**Village of Itasca**  
**Community Development Department**

**MEMORANDUM**

<b>TO:</b>	President Jeff Pruyn Village Board of Trustees	<b>RE:</b>	PC# 19-013 Quadrangle Development Company 870 N. Arlington Heights Road
<b>FROM:</b>	Kon Savoy, AICP Senior Planning Consultant	<b>COTW:</b>	September 3, 2019
<b>CC:</b>	Shannon Malik Jarmusz, AICP CD Director	<b>ENCL:</b>	Plan Commission Staff report, associated documents, and public communications

**RE:** Option Care – 870 Arlington Heights Road  
Preliminary Engineering Review #1  
REL# 19-R0741

**SITE PHOTOMETRIC PLAN**

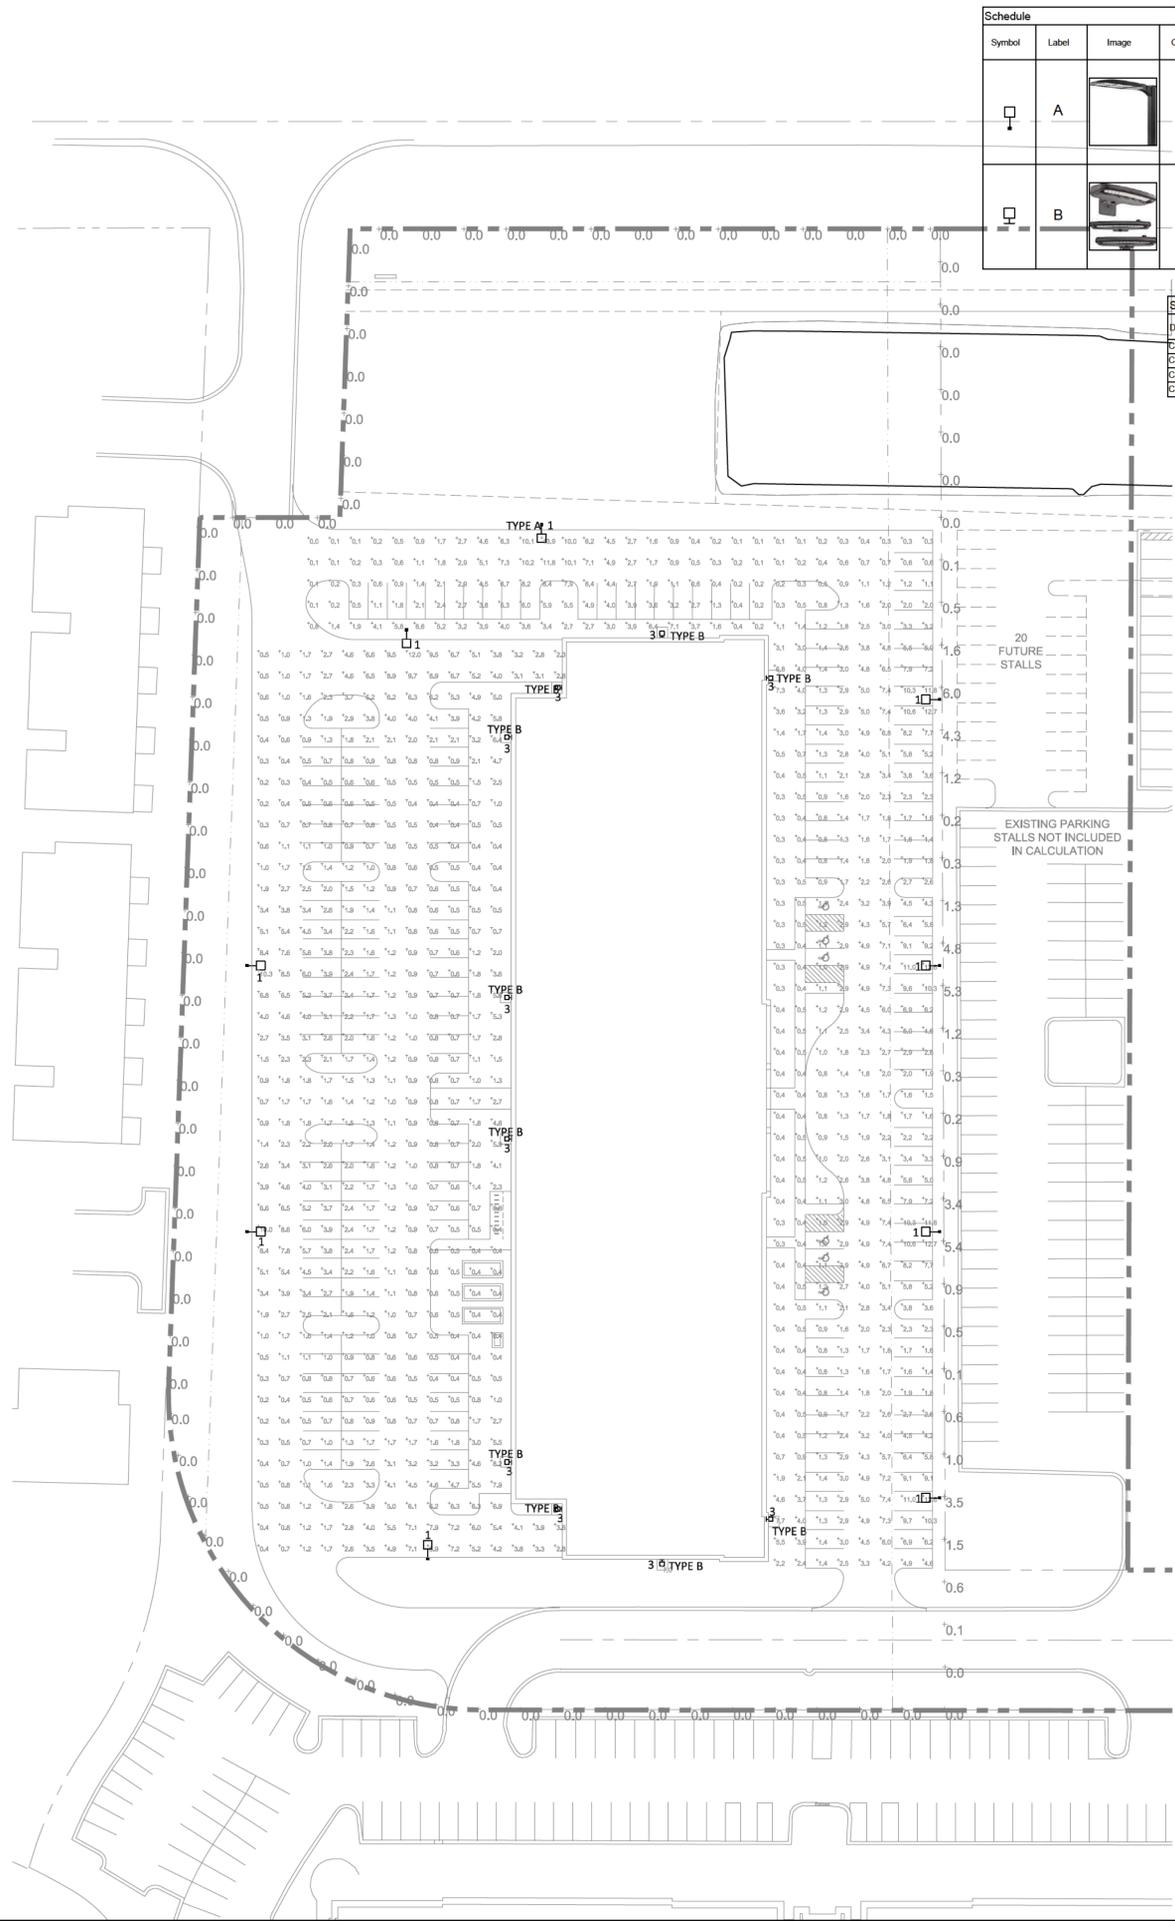
15. The sign plan shall show the setbacks of each ground sign from adjacent property lines. *Comment: the developer has complied*
16. All light levels along the north, west, and south lot lines shall be reduced. *Comment: the developer has complied*

17. Add additional shielding to light fixtures near the west property line to further reduce any glare to adjacent residential properties. *Comment: the developer has complied*
